Comment on se-2022-9

Referee comment on "Tectonic evolution of the Indio Hills segment of the San Andreas fault in southern California, southwestern USA" by Jean-Baptiste P. Koehl et al., Solid Earth Discuss., https://doi.org/10.5194/se-2022-9-RC1, 2022

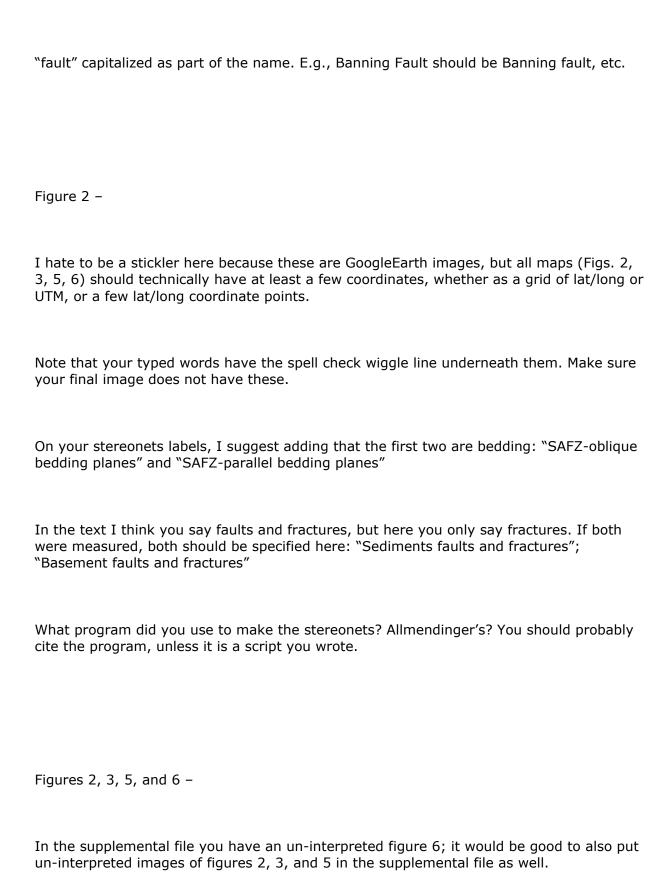
All fault names here, in all figure captions, and throughout the manuscript should not have

Your mapped features (fold hinges and faults) commonly end before the end of the figure's frame, whereas on Figure 2 many of these same features are shown to be continuous across the frame of the figure. I would suggest mapping the features along their full extent and ending them at the end of the figure frame, instead of cutting them short within the figure frame. As currently drawn, it gives the impression to the reader that these folds and faults are short and discontinuous only within the frame of the figure, but Figure 2 shows clearly that many of these features are continuous from one domain into the other. For example, the southeastern corner of Fig. 3b is also the northwestern corner of Fig. 3c – from southwest to northeast there is an anticline then syncline then overturned anticline then overturned syncline/syncline – I think that these are the same folds in both figures, but as currently drawn Figs. 3b and 3c give the impression these are different folds.
